Meeting: 1/21/2026
Applicant: Hitesh Patel ELEVATE Architecture Studio
Owner: Aman Patel Vector Knoxville III, LLC
Project: Moxy Hotel

Staff recommends approval of Certificate 1-C-26-DT, and the three requested modifications to the DK-G dimensional standards, subject to the following conditions.

DESIGN REVIEW BOARD	1-C-26-DT		Petitioner: Hitesh Patel ELEVATE Architecture Studio
	APPLICATION FOR CERTIFICATE OF APPROPRIATENESS		
		137 S. Central St. Level 3: Construction of new building/structure	
Original Print Date: 1/5/2026 Revised:			
Knoxville/Knox County Planning · Design Review Board		 Feet

C101

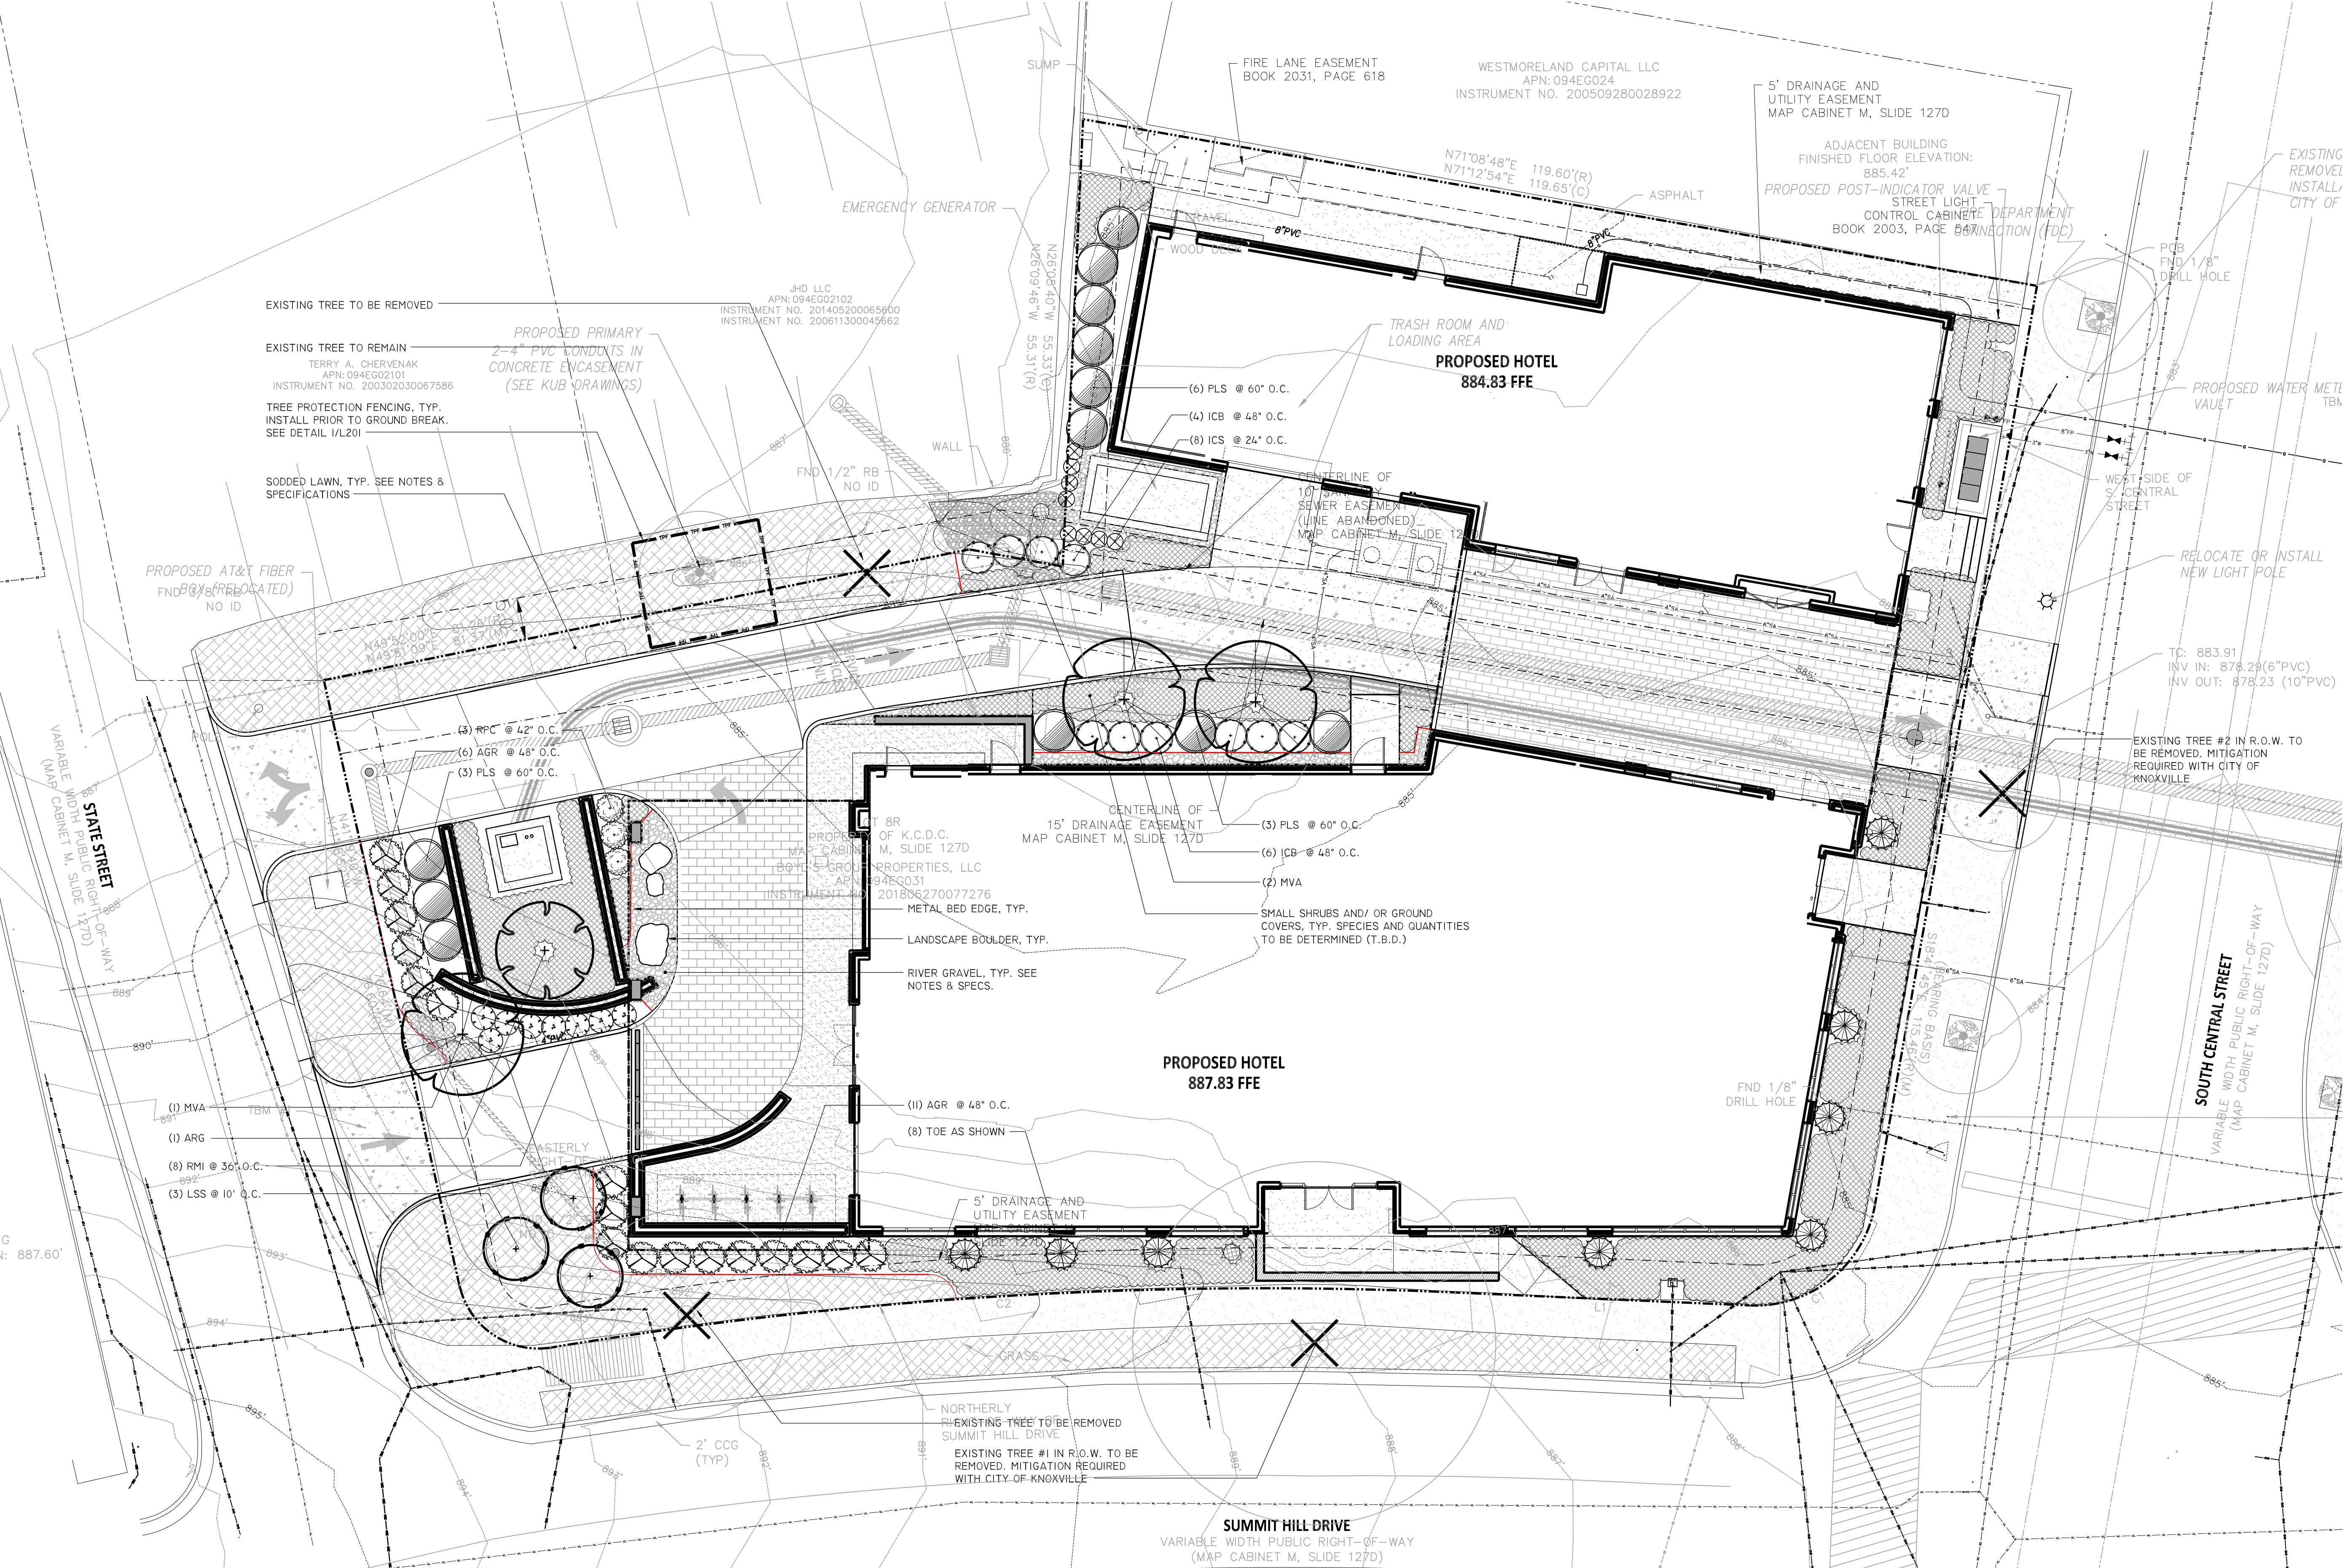
In the DK-G zone, the required BTZ is 0'-5', and the BTZ% is 80%. This means that at least 80% of the building's facade width facing each adjacent street must be within 5' of each street lot line. The applicant is requesting modifications to increase the depth of the BTZ along each street frontage, as outlined below under "requested modifications." If approved by the DRB as requested, the proposed building location will meet the 80% BTZ% along each street frontage. To approve the requested modification, the DRB must determine that the development has been conceived to respect the historic context of the block, to provide greater pedestrian activity at the sidewalk level, and/or to meet other provisions of the guidelines.

— In the staff's opinion, the proposed 9' BTZ (setback) is not consistent with the historic context of the block and does not meet this criterion.

— In the staff's opinion, the increased setback and landscape area between the elevated ground floor and the adjacent sidewalk does not meet this criterion.

a) Respect the historic context of the block — The existing buildings on both sides of the block to the north have varied setbacks because of road closures and realignment when Summit Hill Drive was constructed. — In the staff's opinion, the varied setback of the structure and proposed 8.5' BTZ is consistent with the historic context of the block and meets this criterion.

— In the staff's opinion, the proposed 9' setback is not consistent with the historic context of the block and does not meet this criterion.

B) Provide greater pedestrian activity at the sidewalk level — In the staff's opinion, the increased setback and landscape area between the ground floor and the adjacent sidewalk does not meet this criterion.

B) Provide greater pedestrian activity at the sidewalk level — In the staff's opinion, the increased setback, driveways, and landscape area between the ground floor and State Street does not meet this criterion.

- 1) Obtaining approval from the Board of Zoning Appeals to increase the distance between building entries on the Summit Hill Drive facade to allow the single entry as proposed.
 - 2) Meeting all applicable standards of the Zoning Ordinance on the final plan set.
 - 3) Meeting all applicable requirements of the Department of Engineering and the City's Urban Forestry Division.
 - 4) Submitting the signage package for consideration of approval by the Board under a separate application.
-

1 BUILDING ELEVATION - SOUTH - SUMMIT HILL DR
1/8" = 1'-0"

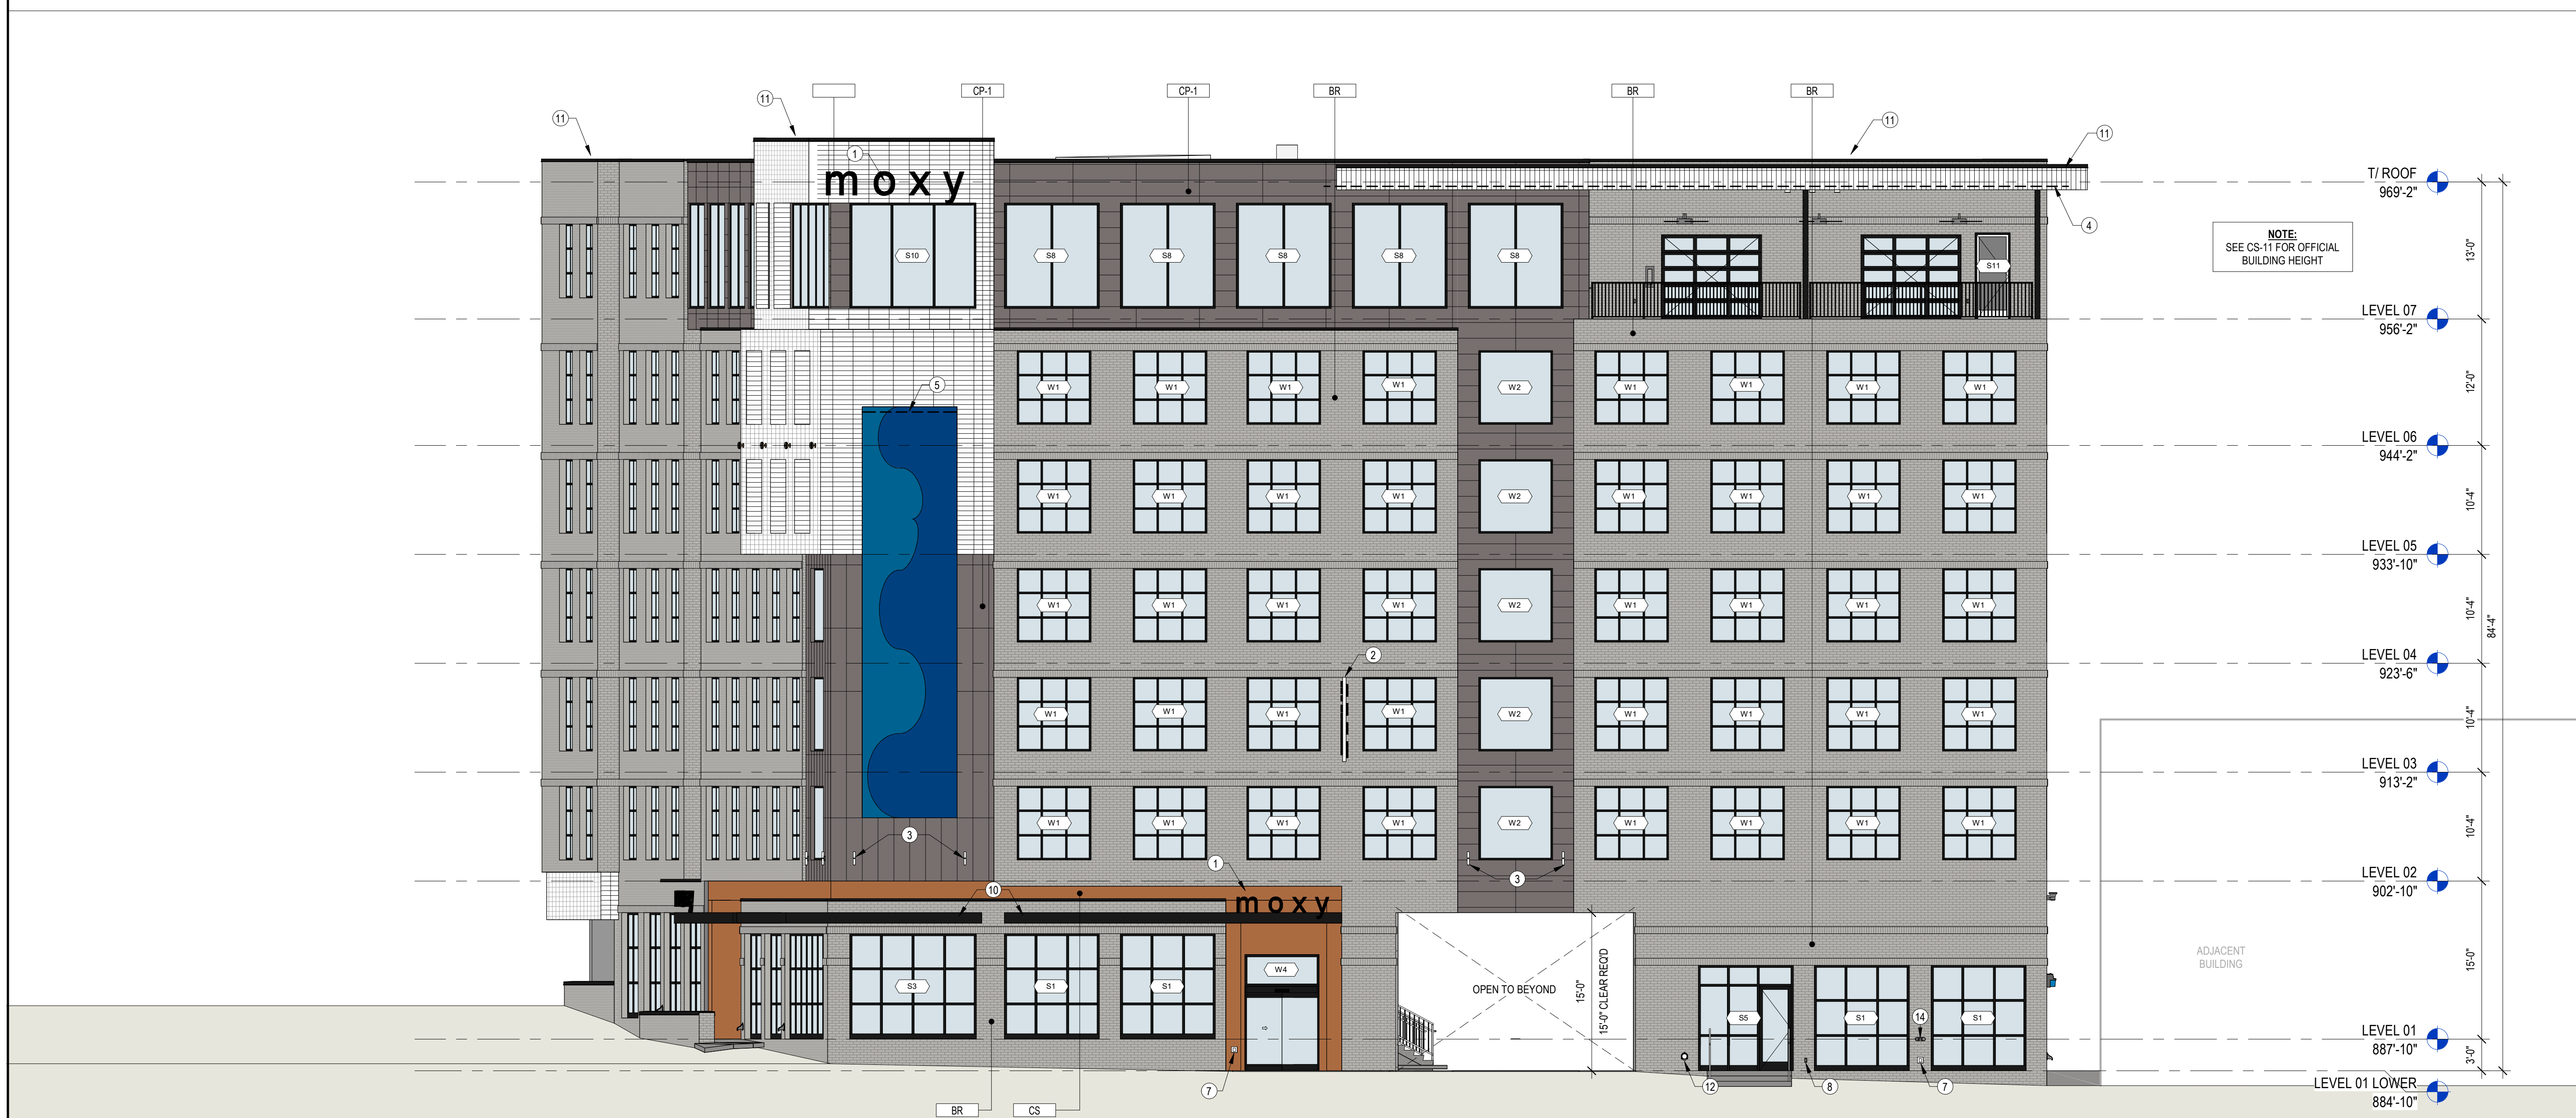
— The entry on the Summit Hill Drive façade is 54'-3" from the S. Central Street corner of the building, and 56'-2" to the opposite corner, exceeding the maximum 50' separation between entries. The DRB does not have the authority

to approve modifications to the DK subdistrict design standards. The applicant's options are to revise the plan by adding a second entry to this façade or obtain a variance from the Board of Zoning Appeals to increase the maximum separation between entries. If a second entry is proposed and the current entry is shifted to meet this design standard, these revisions may require approval by the DRB.
